CALIFORNIA COASTAL COMMISSION

**STAFF REPORT: PERMIT AMENDMENT**

APPLICATION NUMBER: 5-98-156-A4

DESCRIPTION OF CURRENT AMENDMENT 5-98-156-A4 REQUEST:

EXHIBIT # 5

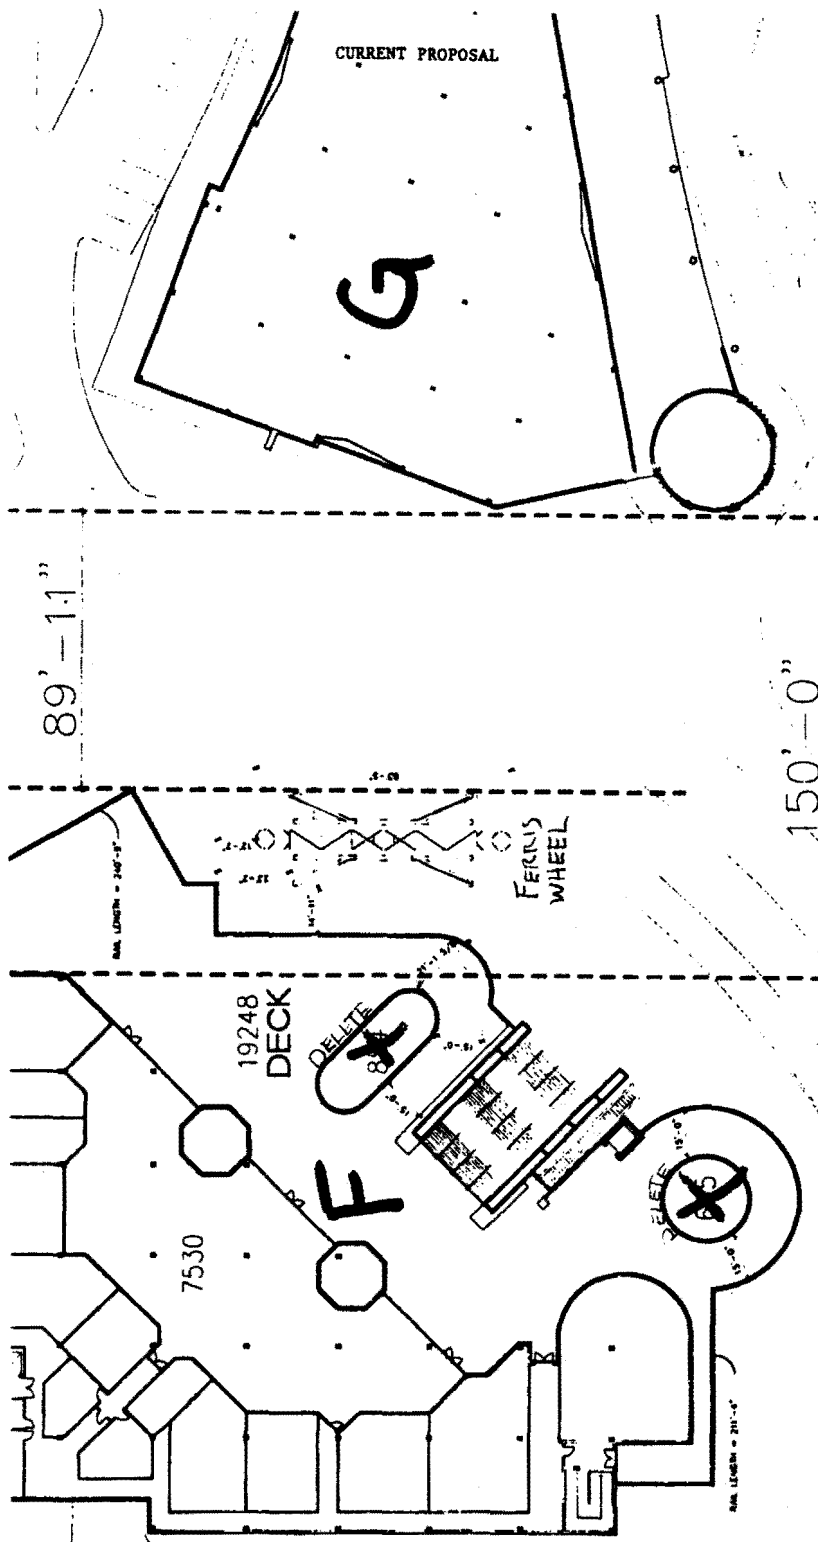
The applicants now propose to revise Building F which has been approved at the southwest corner of the intersection of Shoreline Drive and Aquarium Way (Exhibits #2&5). The proposed revision to Building F would reduce the area of the building's footprint and reduce the area of the required second-level public viewing deck from 35,000 square feet to 17,749 square feet. The proposed reduction in the footprint of Building F would also widen the required Aquarium Way view corridor (between Building F and Building G south of Shoreline Drive) from the previously approved 60-foot width to a 90-foot wide view corridor (Exhibit #5).

The applicants now propose a smaller footprint for Building F and a resulting reduction in the size of the required second-level public viewing deck from 35,000 square feet to 17,749 square feet. The proposed reduction in the footprint of Building F would also widen the required Aquarium Way view

corridor (between Building F and Building G south of Shoreline Drive) from the previously approved 60-foot width to a 90-foot wide view corridor (Exhibit #5).

The Commission finds that the proposed widening of the Aquarium Way view corridor from 60 feet to 90 feet would result in improved public views from Shoreline Drive due to the proposed 33 percent increase in the width of the view corridor. In addition, the additional width of the view corridor, where commercial uses and most structures over 42 inches are prohibited, would substantially increase the area of public open space between Buildings F and G. The required pedestrian bridge over Shoreline Drive is not proposed to be revised, and therefore would still provide the same expansive and uninterrupted views of Rainbow Harbor and the Queen Mary as anticipated in the original approval of Coastal Development Permit 5-98-156.

The proposed ~~35,000~~ 17,749 square foot public viewing deck on the second level of the building (Building F) proposed to be built between the City-owned parking structure and Aquarium Way shall be constructed and opened to the public concurrent with the development that occurs within the 150-foot wide view corridor/open space area at the intersection of Shoreline Drive and Aquarium Way (See Exhibit #9 of staff report dated 1/14/99). The public viewing deck shall be available for public use, including picnics, as public parks are. Park benches and tables for picnics ~~eating~~ shall be provided for general public use on the viewing deck. Take-out and walk-up food services are encouraged behind the viewing deck, but restaurant table service is prohibited. Commercial uses and kiosks are prohibited within the proposed 17,749 square foot public viewing deck.

EXHIBIT # 8

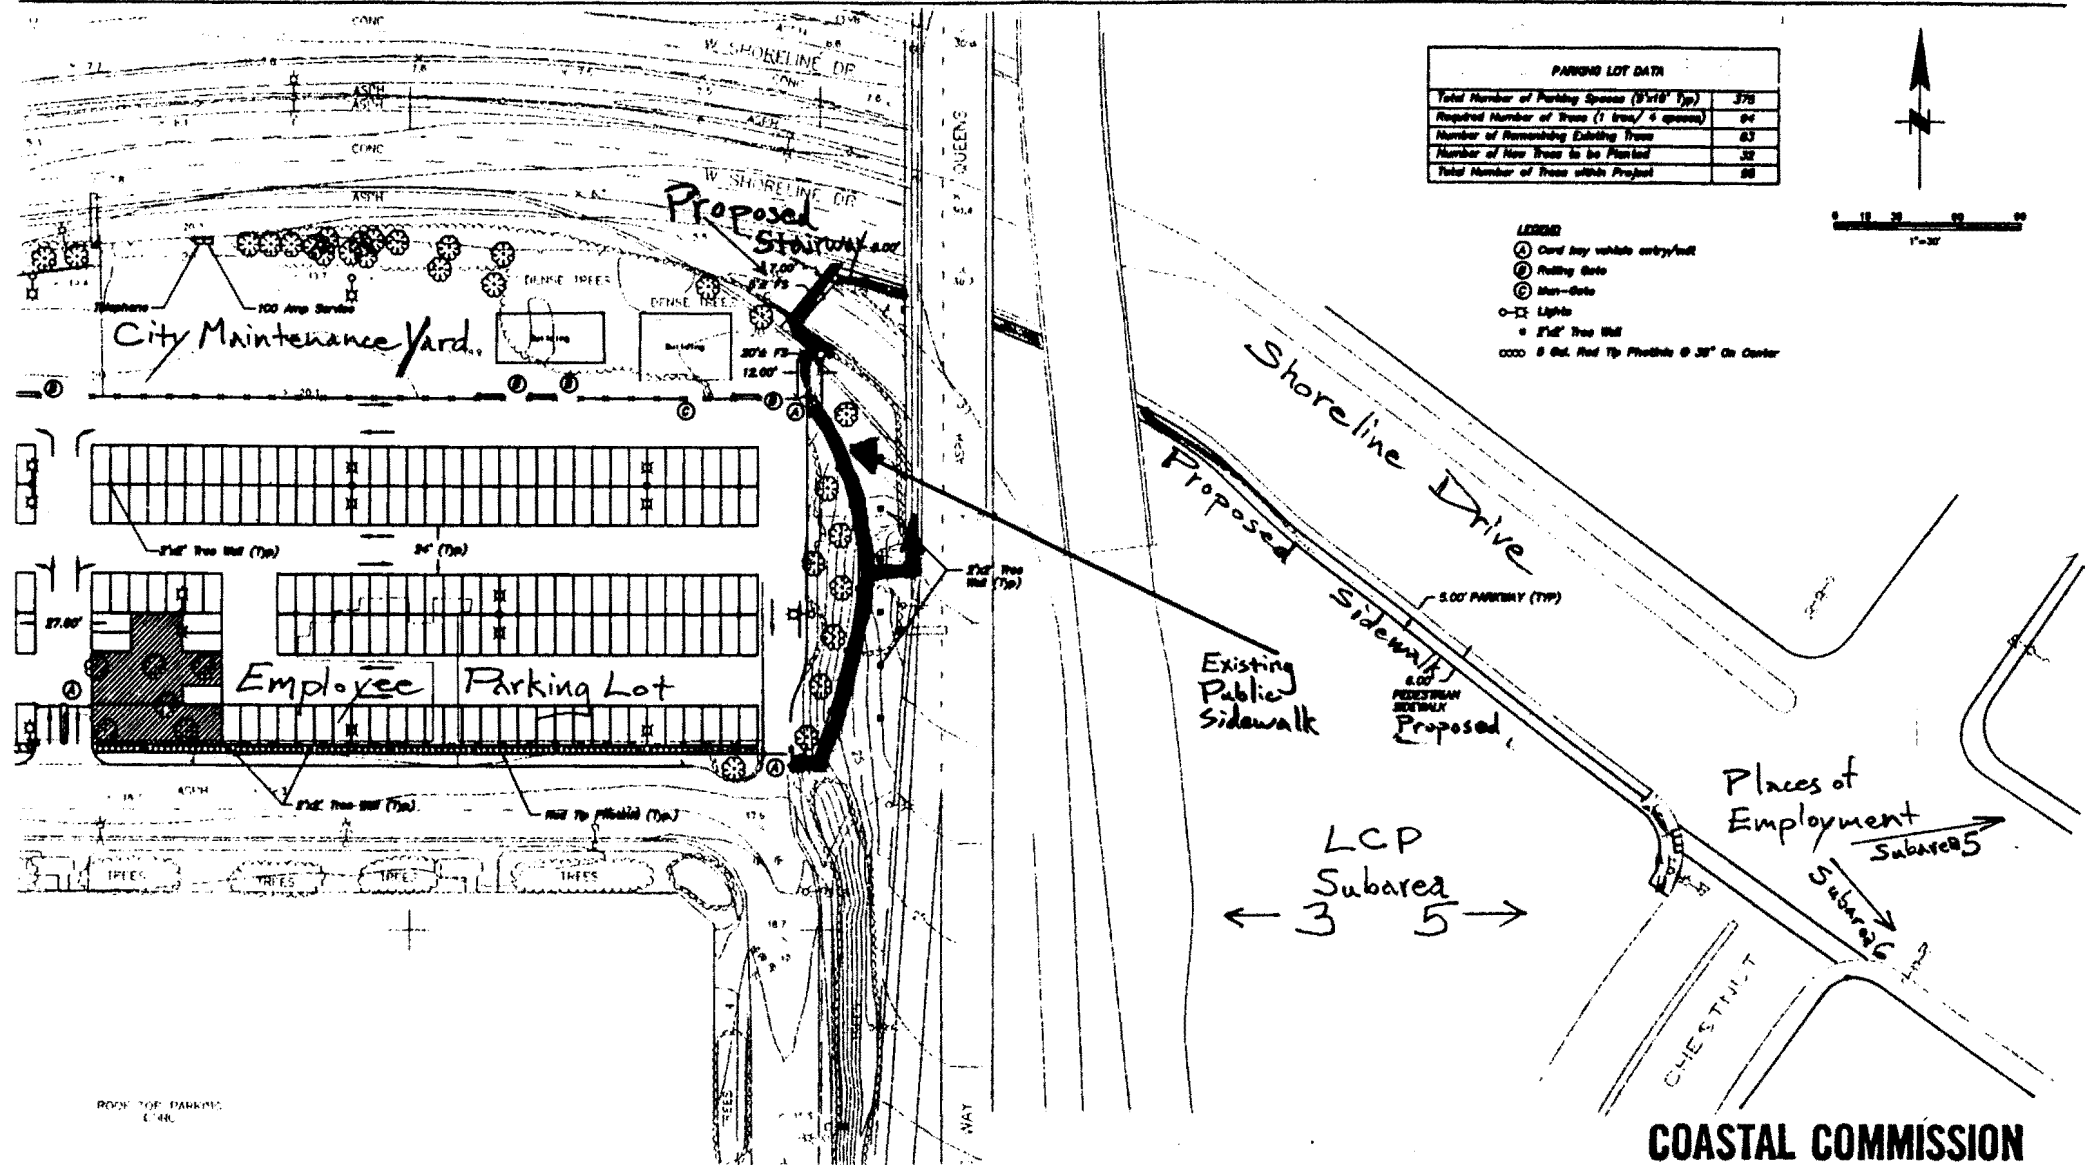
The applicants propose to construct a public sidewalk and stairway to connect the previously approved employee parking lot in Downtown Shoreline LCP Subarea 3 to the previously approved commercial uses in LCP Subareas 5 and 6 (Exhibit #8). Downtown Shoreline LCP Subareas 5 and 6 are already interconnected by the existing pedestrian access system (sidewalks and Esplanades). The proposed six-foot wide pedestrian accessway would extend westward from the existing public sidewalks located at the intersection of Shoreline Drive and Chestnut Place to an existing public sidewalk located on the west side of Queens Way, an elevated City street and bridge that connects Downtown Long Beach to the South Shore of Queensway Bay (Exhibit #2).

Part B: Stairway & Sidewalk to connect existing pedestrian access system in LCP Subarea 3 to existing pedestrian access system in LCP Subarea 5.
See Exhibit # 2 also.

The public sidewalk and stairway proposed along the south side of Shoreline Drive connecting the existing public pedestrian access systems in LCP Subarea 3 to LCP Subareas 5 and 6 shall be constructed concurrent with the commercial development approved in LCP Subarea 5. The proposed public sidewalk and stairway linking the existing public pedestrian access systems in LCP Subareas 3, 5 and 6 shall be opened to the general public prior to the date of issuance of the first certificate of occupancy within the development permitted by Coastal Development Permit 5-98-156. Public access along the proposed and existing pedestrian accessways in LCP Subareas 3, 5 and 6 shall remain open and unobstructed for use by the general public. No gate or other obstruction is permitted on any proposed or existing pedestrian accessway in LCP Subareas 3, 5 or 6.

Restaurant Table Service Prohibited.
Areas A-F Permitted for public seating & public tables.

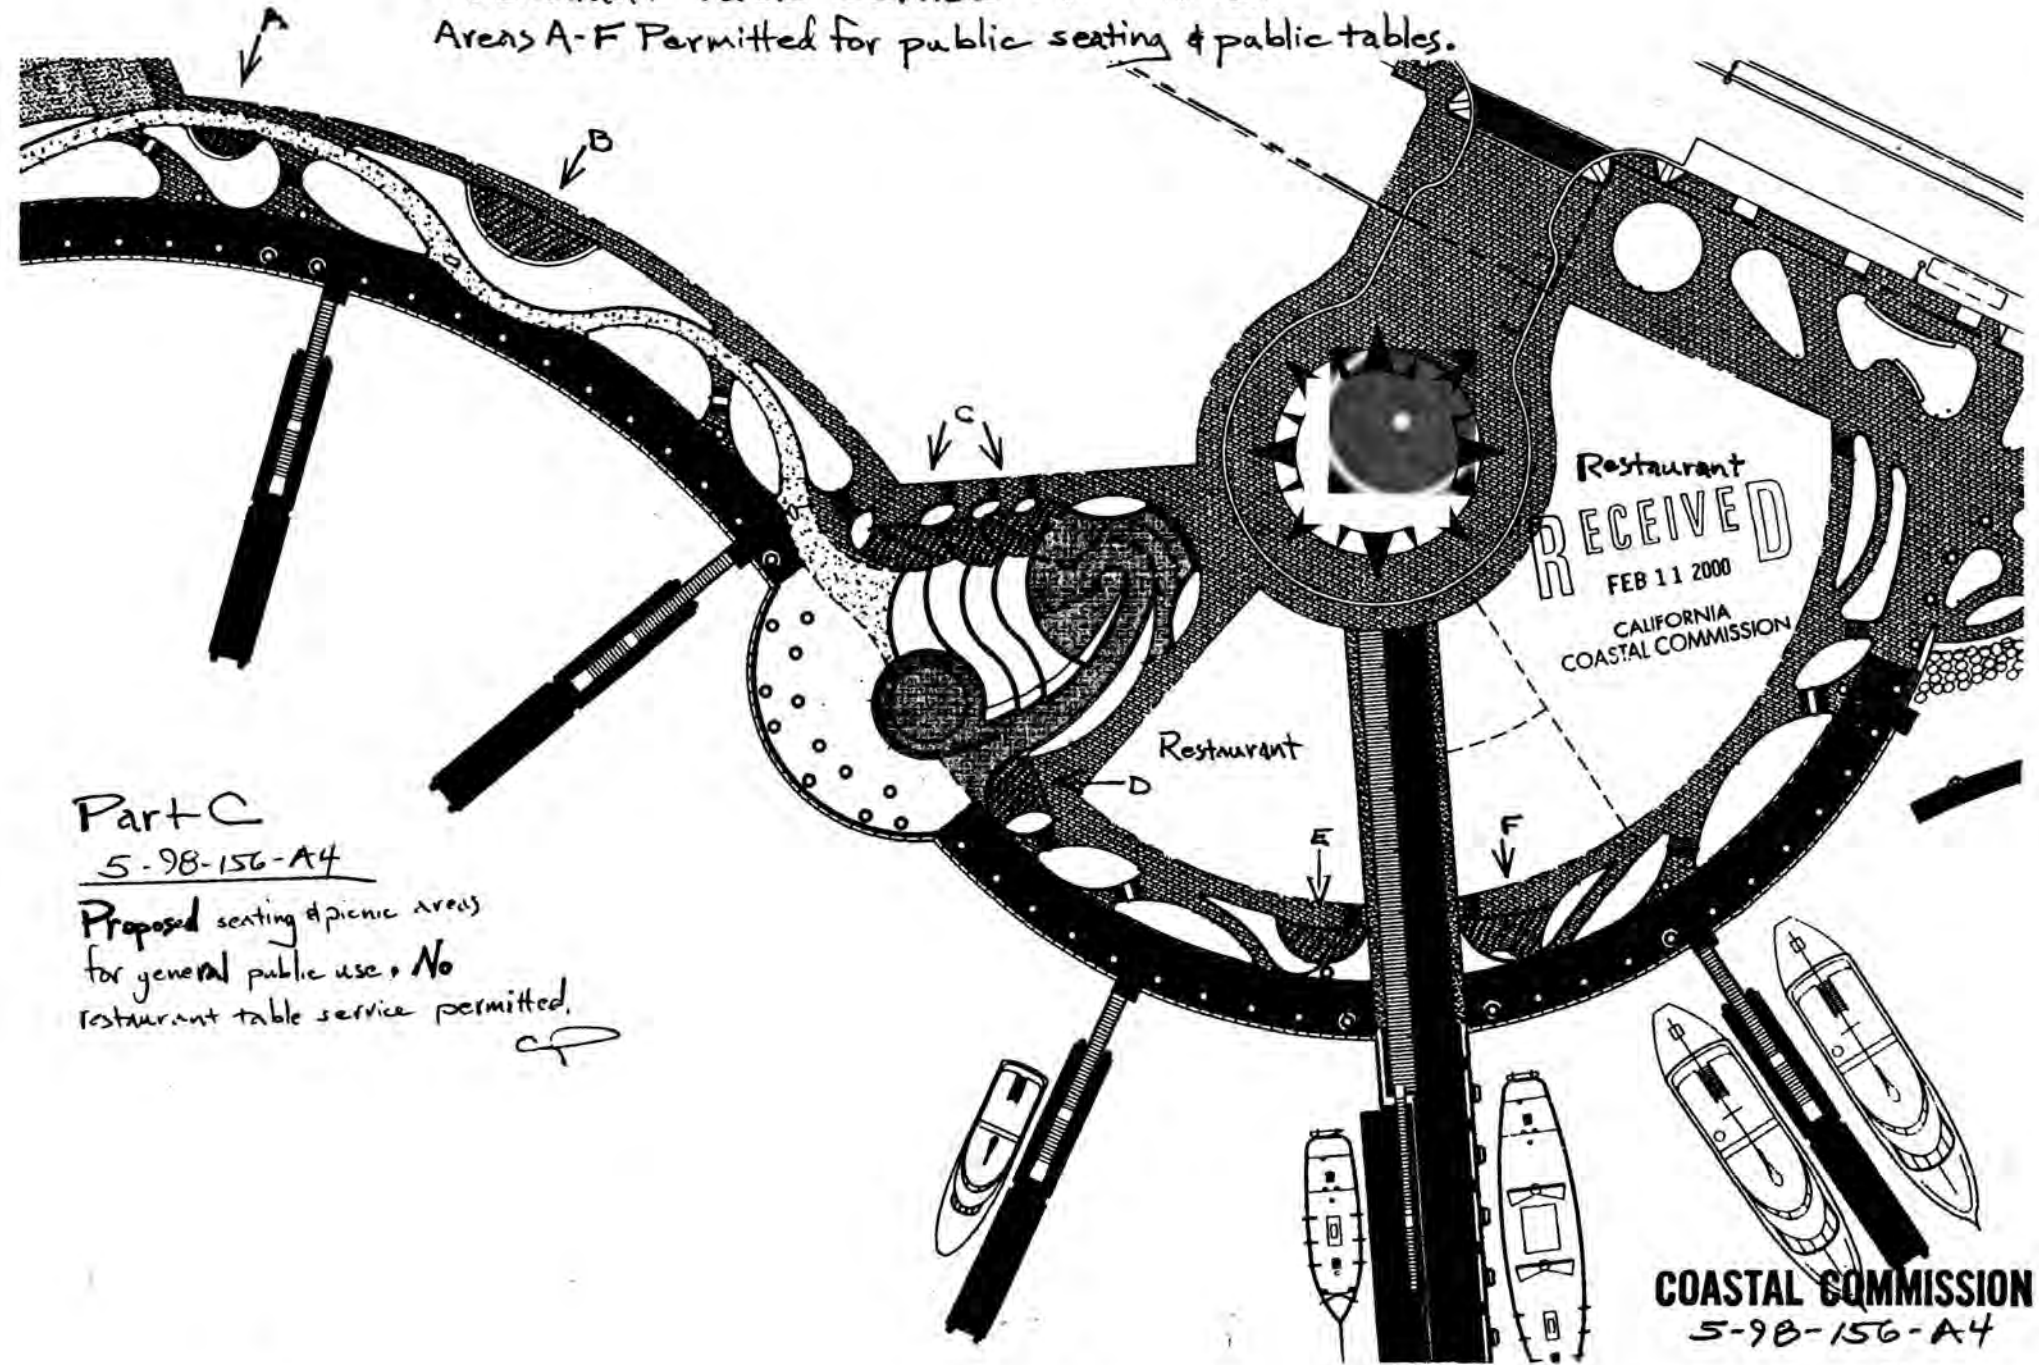
The applicants have requested Commission approval to place picnic tables and chairs along specified sections of the upper Esplanade of Rainbow Harbor (Exhibit #9). As proposed, the picnic tables and chairs would be available for use by the general public consistent with the public park designation of the entire Rainbow Harbor Esplanade. No restaurant table service is proposed on the Rainbow Harbor Esplanade.

Public seating and tables for designated public picnic areas (restaurant table service is prohibited) may be provided on the upper portion of the Rainbow Harbor Esplanade as shown on Exhibit #9 of the staff report dated February 24, 2000. All tables placed in the areas designated on Exhibit #9 of the staff report dated February 24, 2000 shall be clearly designated for use by the general public and shall be engraved or posted with signs stating: "No Purchase Required". Areas where restaurant table service is prohibited includes (but is not limited to): Shoreline Park, Rainbow Harbor Esplanade (upper and lower portions), the Terraces at the end of Pine Avenue, the entrance to Pine Avenue Pier, and Shoreline Wharf.
